I PROJECT:	Wynot Public School Addition & Renovation	PROJECT NO.	L14208
FROM:	BVH Architects	DATE:	17 March 2016
TO:	All Bidders	ADDENDUM NO.	1

Wynot Public School Addition and Renovation
R.O. Youker, Inc. Project #16005
Addendum 1 Items
3/17/2016

addendum no. 1

A10 FIRST FLOOR DEMOLITION PLAN
 1/16" = 1'-0"

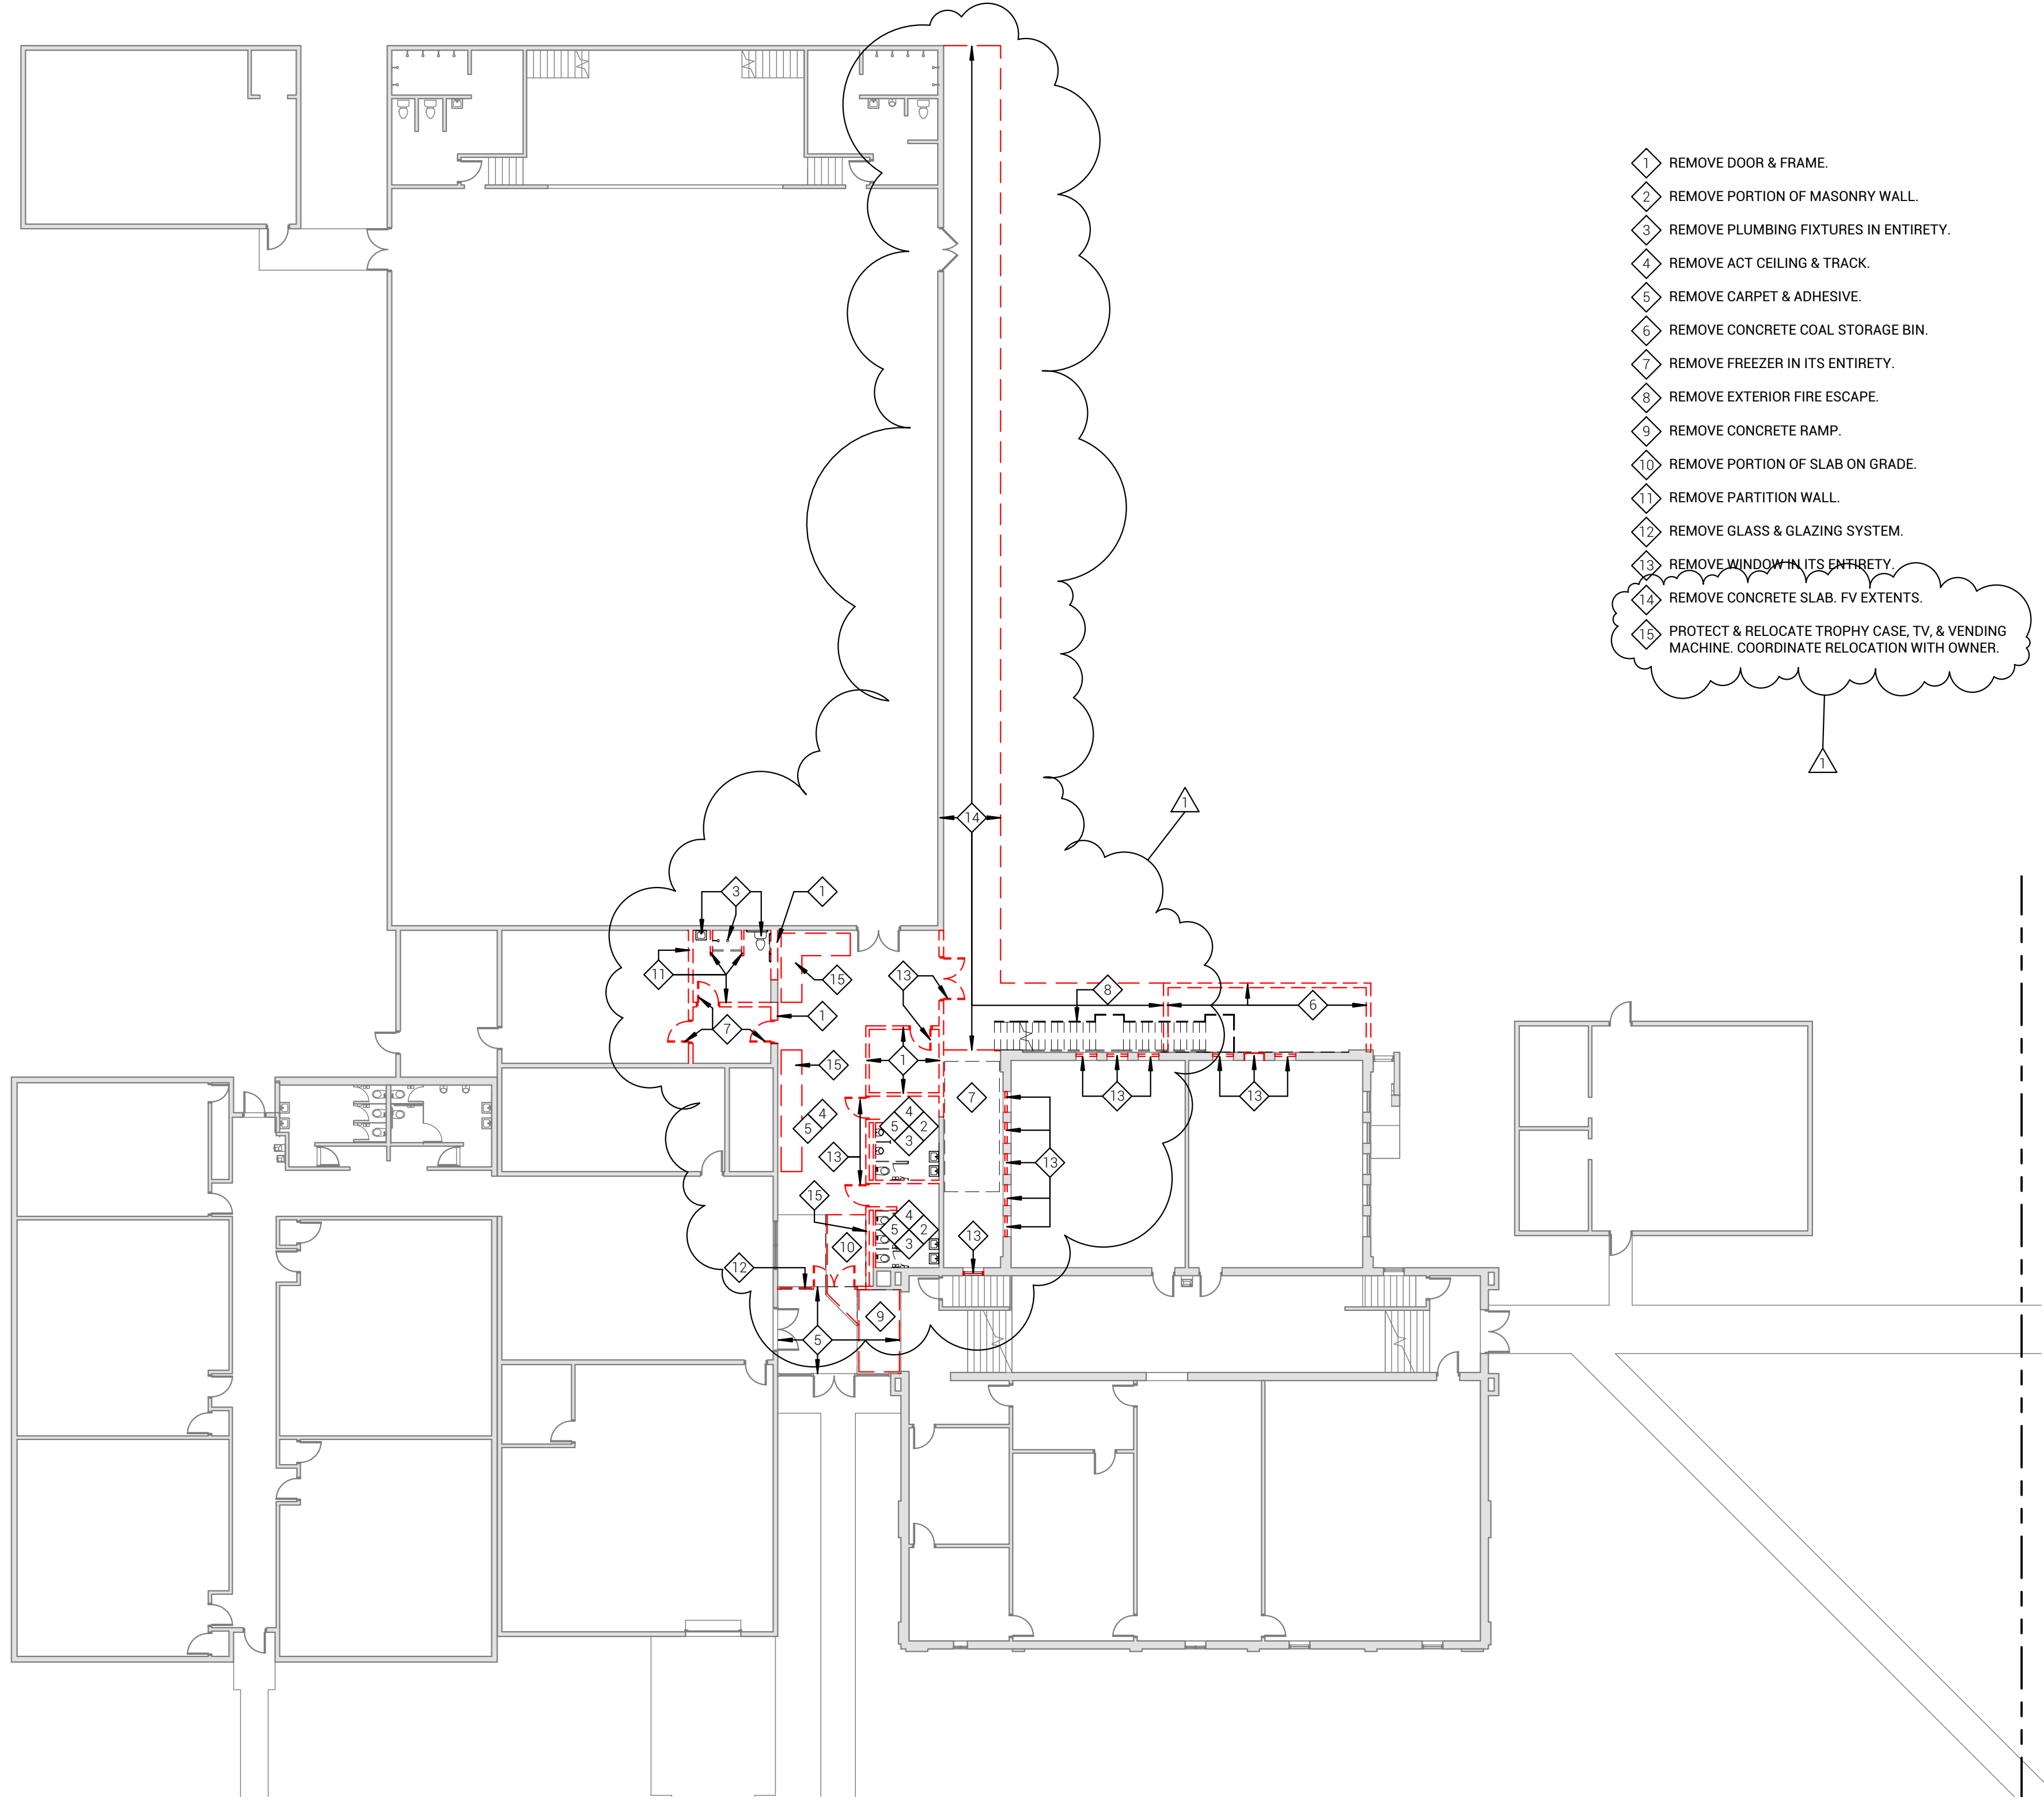
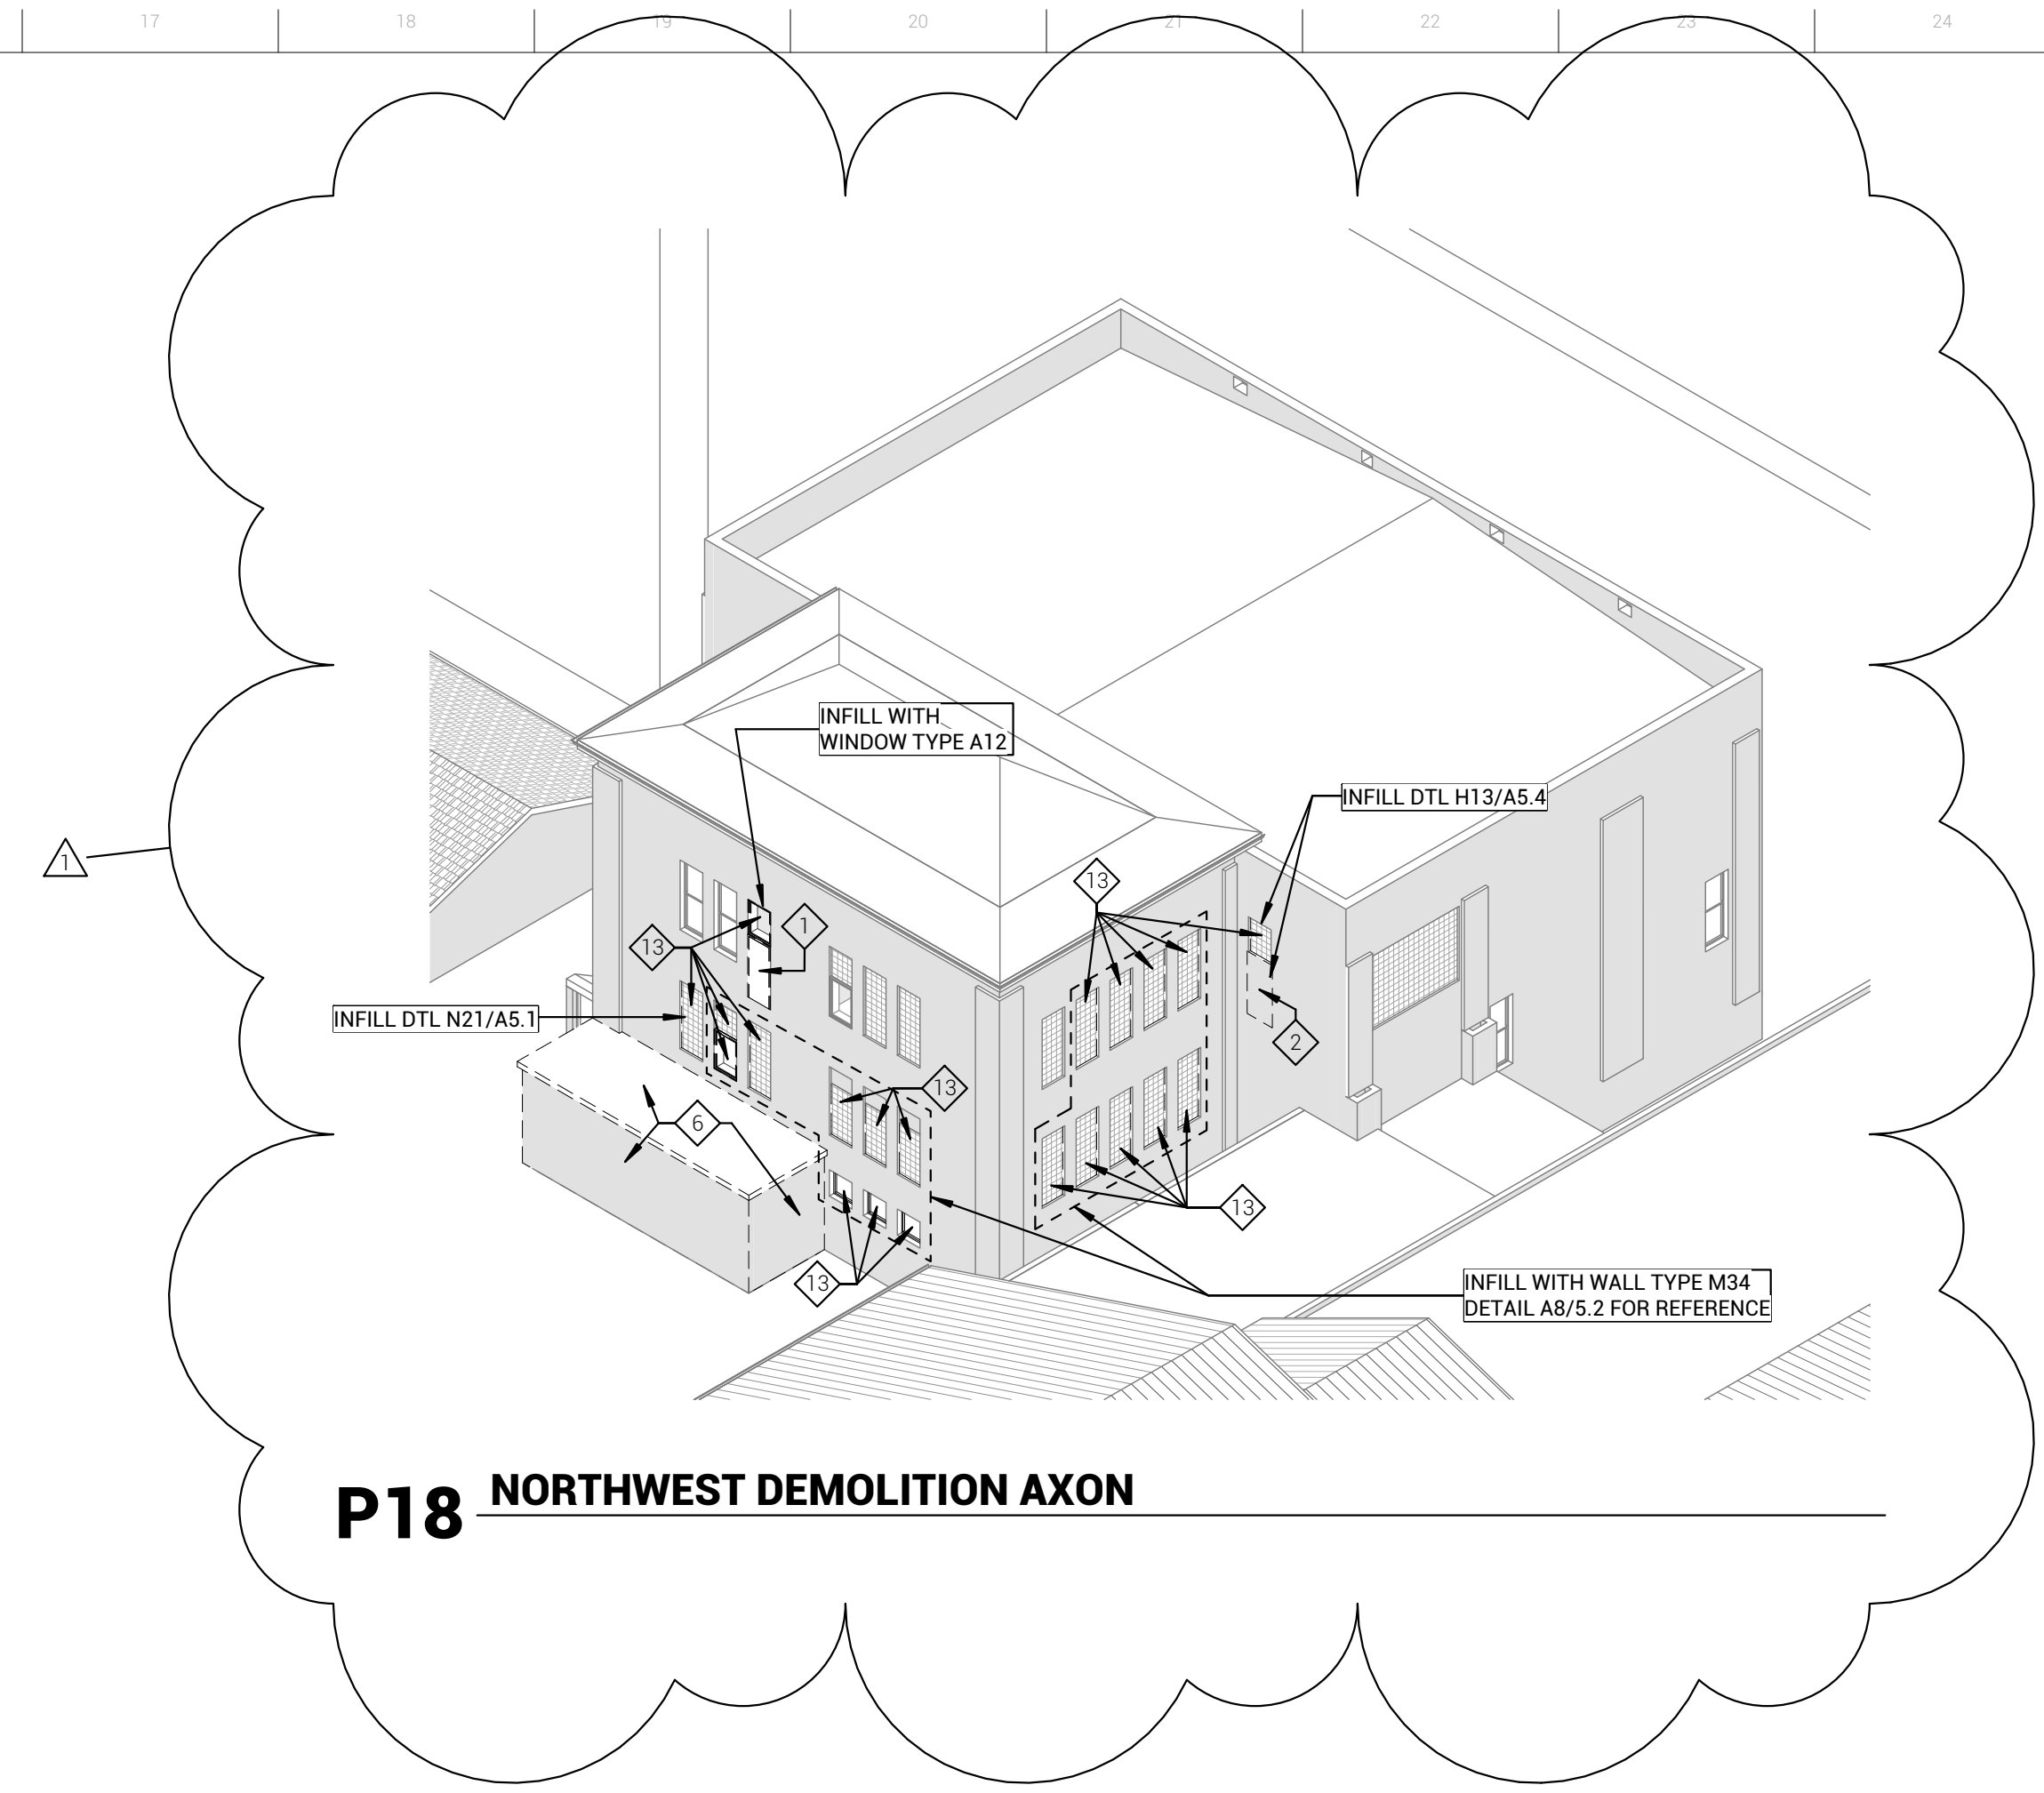
- b. Drawing A10
 1. Demolition Keynotes 14 & 15 added and indicated on plan
4. Sheet A5.2 Wall Sections
 - a. Detail A8
 1. Infill detail applies to existing door and window openings. Field Verify location of windows. Apply sheet waterproofing to new portions of wall, overlapping existing masonry.
